We would like to thank the referee for the review and comments to improve the quality of this work. Following these comments, we have made major modifications and point-by-point responses. Please find our response below (in blue).

Overall, the preprint is well-written and easy to read. A technical study assessing the long term, tower-based capabilities of an Aeris MIRA instrument for methane and ethane measurements is a valuable contribution to scientific literature. Except for several areas that need more clarity, instrument characterizations appear to be scientifically sound and of relevance for future field studies. My primary concerns in this preprint are the insufficient field assessment for ethane measurements and why some instruments did not undergo all or any of the laboratory tests. Additionally, there are several areas that need more clarity in the paper. In short, I think this paper is quite interesting and captures the potential for MIRA-based methane measurements in long-term monitoring, but more work needs to be done to assess the potential capability of long-term MIRA-based ethane measurements.

Figure S2: (a) Calibrated hourly ethane data from Aeris MIRA Ultra instruments (serial number A778 and A798) at CAO over the time period of June 2024, and (b) the difference of ethane between these two Aeris MIRA Ultra instruments.

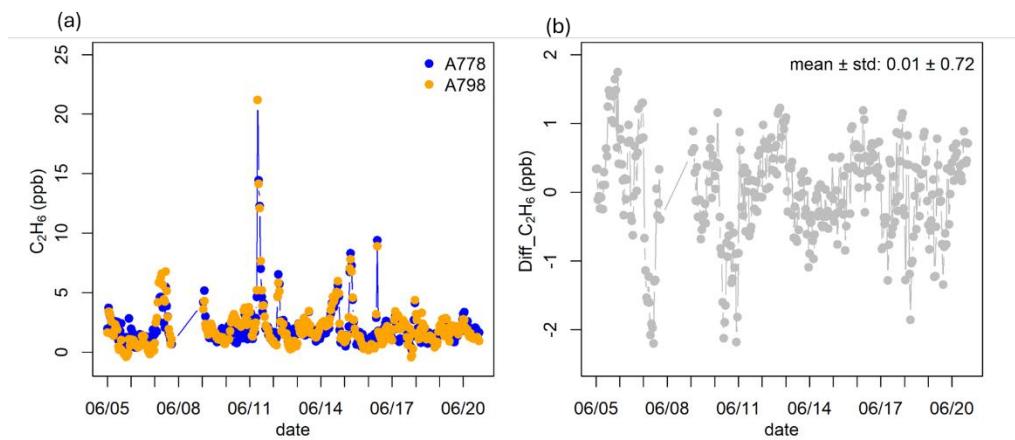
The introduction is easy to read with appropriate background information included. The introduction (line 61-62) and the title of the paper suggest that a large part of the novelty of this study is the laboratory and field assessment of MIRA Ultra for a long-term, tower-based network of both dry methane and ethane. The author understands that the collocated measurements of methane and ethane are important for distinguishing thermogenic methane emissions from total methane emissions. The preprint, however, does not adequately demonstrate confident tower-based ethane measurements.

We unfortunately do not have other continuous (measurement frequency  $\sim$ 5 s) instruments with ethane measurements available for a long-term comparison in the field. We did have two Aeris instruments co-located at CAO for about one month (June 2024). These instruments have different noise levels (based on Allan-Werle deviation tests), different water responses, and they were calibrated with separate cylinders. Although it would be preferable to compare the result to a known instrument, the comparison between the two Aeris instruments is quite independent (with results as shown below). The mean difference of ethane was well within the goal of 0.3 ppb  $\text{C}_2\text{H}_6$ . The instruments were calibrated every three hours and showed a relatively higher standard deviation (i.e., if we were to re-do this knowing what we now know, we would do hourly low cylinder calibrations). The figure was added to the supplementary material. We added a sentence to the methods (Line 263 on page 10): "Additionally, we deployed two Aeris instruments with separate calibration cylinders at CAO for about one month in June 2024." We added a sentence to the results: "The mean difference of ethane for two independent Aeris systems deployed at CAO for June 2024 was 0.01 ppb  $\text{C}_2\text{H}_6$  (Figure S2)." was added to Line 417.

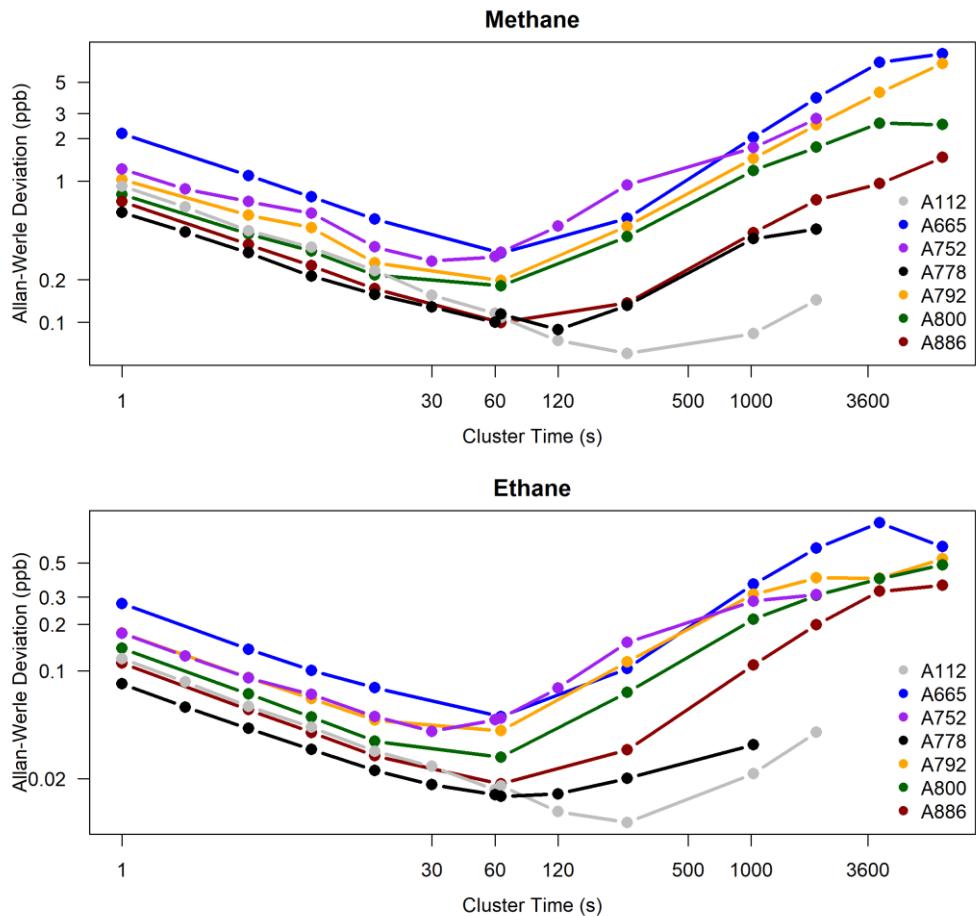
- **Section 2.2: bias and precision goals:** The primary take away in this section is the reference precision goal, however, it is unclear how the authors derive 3ppb as the methane goal. < 10% of the typical enhancement should be 4ppm (based on line 488). Overall, this section can be written more clearly as well as concisely.

To clarify Section 2.2, we rewrote it as “We set bias (defined as the long-term mean deviation from the true value) and precision (defined as the standard deviation of hourly differences) guidelines for CH<sub>4</sub> and C<sub>2</sub>H<sub>6</sub>. In general, network compatibility goals are the maximum instrument biases that can be accepted without adversely affecting model interpretation of gradients (GAW Report No. 292, 2022), whereas the total uncertainty contains both bias and random noise. Summertime tower CH<sub>4</sub> enhancements in the Permian Basin averaged around 60 ppb, while wintertime enhancements averaged around 200 ppb (Monteiro et al., 2022). Considering the lower emissions with CH<sub>4</sub> enhancements around 40 ppb in the Denver-Julesburg Basin, a desire for bias less than 10% of typical network enhancements any time of the year, and instrument capabilities, we adopted a more conservative bias goal of 3 ppb CH<sub>4</sub>. The average C<sub>2</sub>H<sub>6</sub> to CH<sub>4</sub> ratio is about 5%-10% including all biogenic and thermometric methane sources at the Denver-Julesburg Basin area (Daley et al., 2025). Considering also instrument capabilities, we set the corresponding bias guideline for C<sub>2</sub>H<sub>6</sub> at 0.3 ppb. We set precision guidelines for the hourly differences (3 ppb CH<sub>4</sub> and 0.3 ppb C<sub>2</sub>H<sub>6</sub>) to limit the deviations that may impact emissions from inversion modelling on shorter timescales, e.g., weekly. Future instrument improvements allowing further reductions in bias and noise would be beneficial, particularly for regions with lower emissions.”

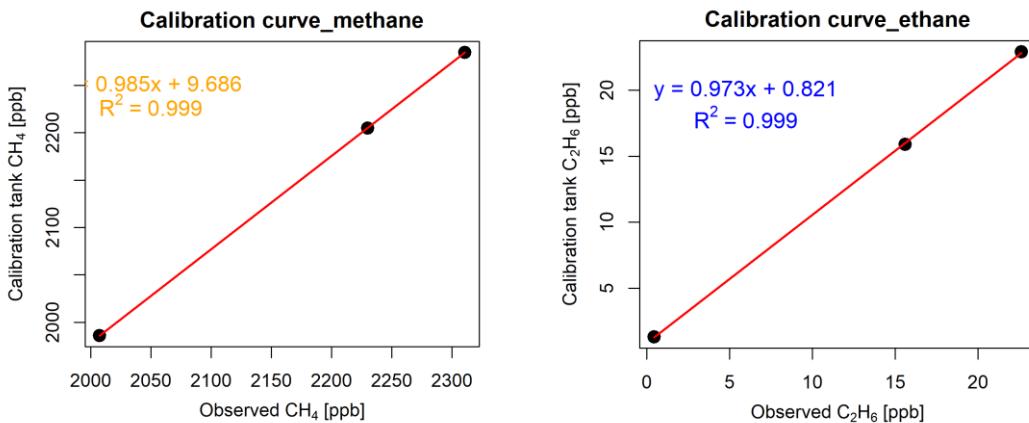
In test three, why did you include all calibration cycles (line 166), when the cylinders did not stabilize for the first few hours? Shouldn't the ‘NOAA C<sub>2</sub>H<sub>6</sub>’ column also include the cylinder assignment error?

It was mentioned at Line 165-Line 166 that “The initial instability occurred for all cylinders and the cause is unknown.” And we also added that “Because the cause and period of instability remain unknown and no clear threshold for exclusion could be established, we included all the calibration cycles in Test 3 for transparency and reproducibility. Excluding a consistent number of cycles as warm-up for each cylinder did not appreciably affect the final calibrated cylinder values.” to Line 166.

Regarding the NOAA C<sub>2</sub>H<sub>6</sub> column, the ethane mole fractions used in our analysis were those assigned by the NOAA CCL for the tertiary standards. NOAA does not provide an additional “cylinder assignment error” for these values, so no such uncertainty term could be included.

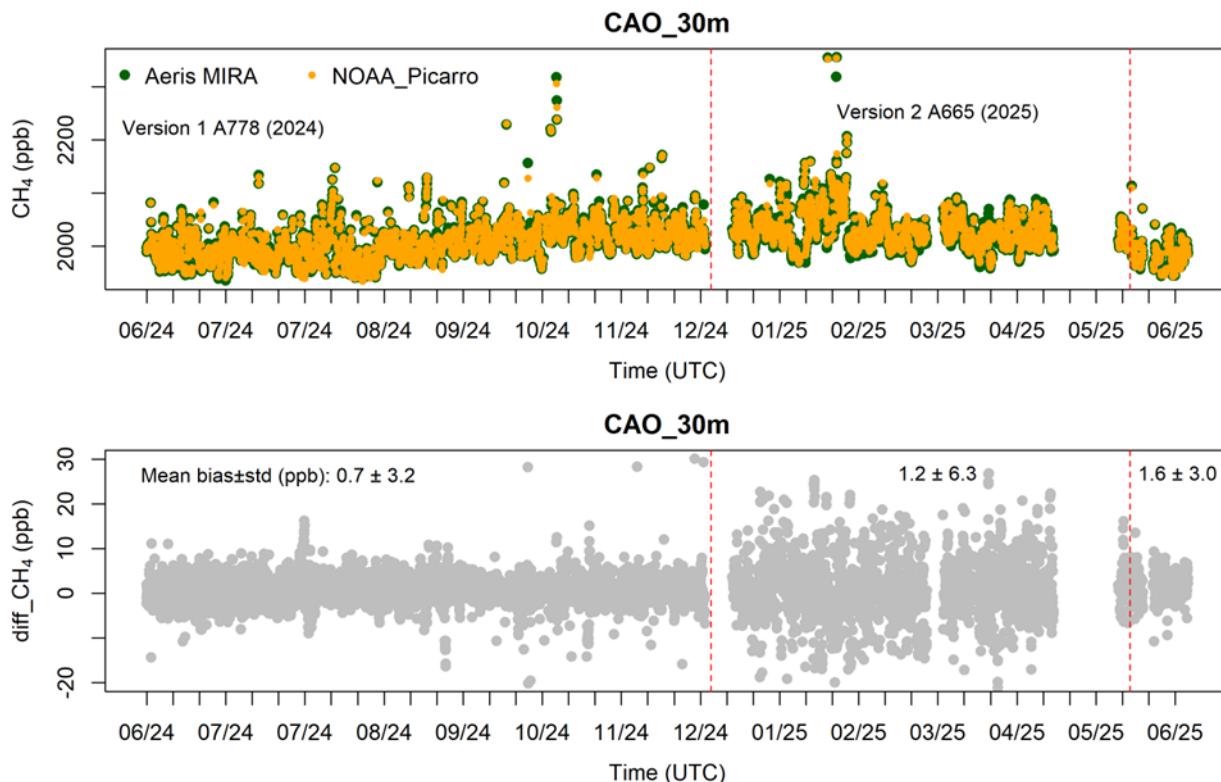
- **Water Vapor corrections:** What does a perfect water correction mean (135-136)?

The sentence was rewritten as “If the water correction was correctly described by a stable relationship in the manufacturer software, the reported CH<sub>4</sub> and C<sub>2</sub>H<sub>6</sub> dry mole fractions would not depend on the water vapor level of the resulting air.”
